ADDENDUM NO. 1

RED CLAY CONSOLIDATED SCHOOL DISTRICT
WILLIAM F. COOKE, JR ELEMENTARY SCHOOL
2025 Graves Road, Hockessin, DE 19707

THE WHITING-TURNER CONTRACTING COMPANY
CONSTRUCTION MANAGER
131 Continental Drive – Suite 404
Newark, DE 19713
302-292-0676 (phone)
302-292-0683 (fax)

2 OVERALL SECOND FLOOR CLERESTORY PLAN

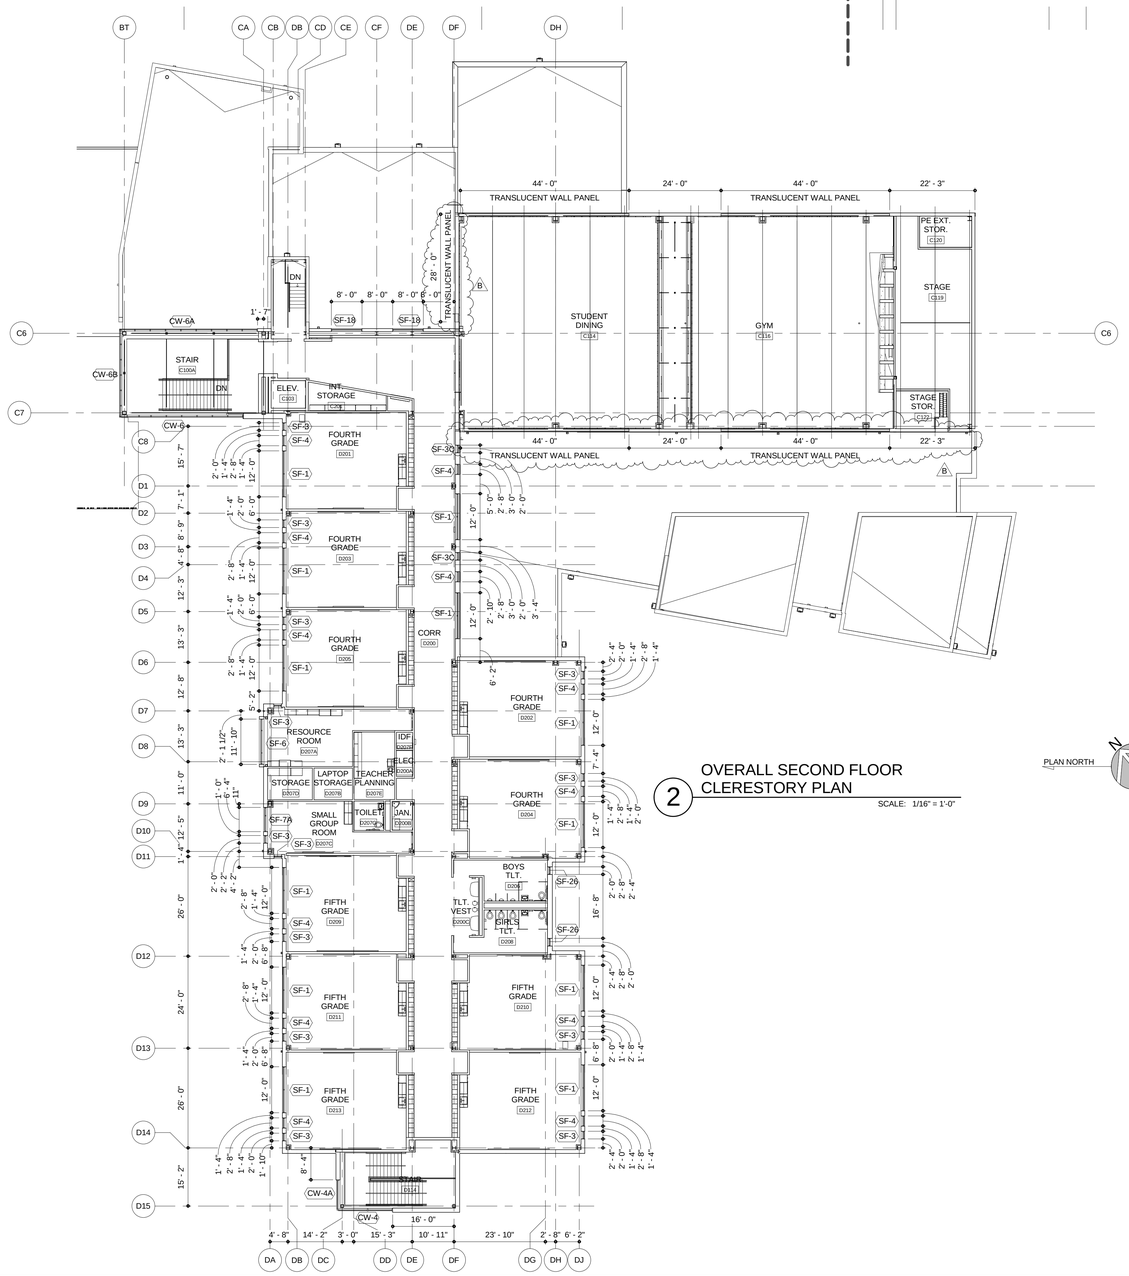
3.49.1 REPLACE Drawing A104 with drawing issued in this addendum.
3.49.2 REVISE dimensions / notes pertaining to location of Translucent Wall Panels at 2/A104. Refer to exterior elevations, building sections, wall sections, and details for additional information.

1 FIRST FLOOR REFLECTED CEILING PLAN - AREA D

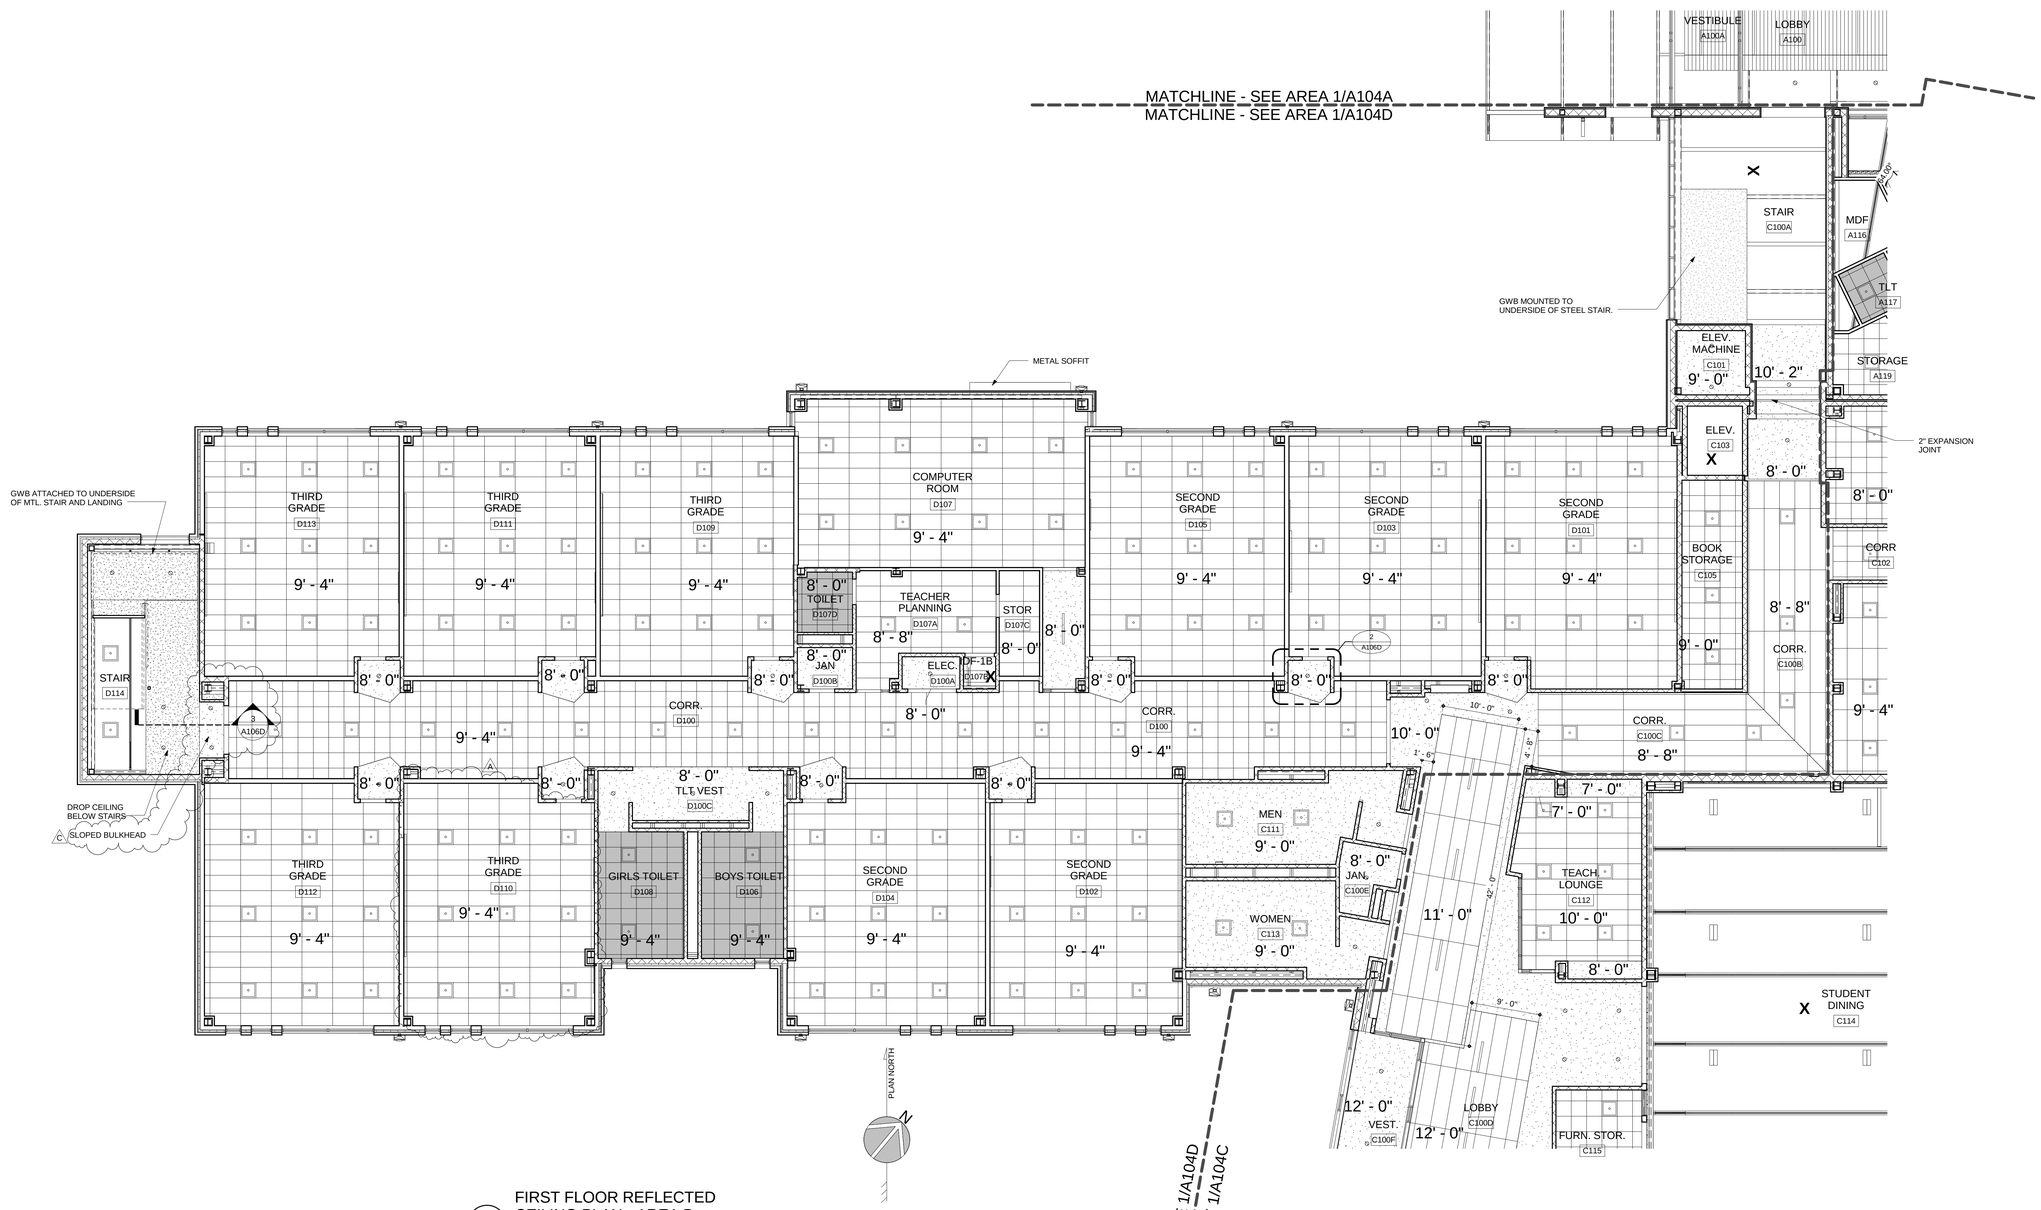
3.50.1 REPLACE Drawings A106D with drawing issued in this addendum.
3.50.2 ADD ACT-2 and Light Fixtures (see electrical) at Room D110 THIRD GRADE.
3.50.3 ADD detail of sloped bulkhead at Stair D114.
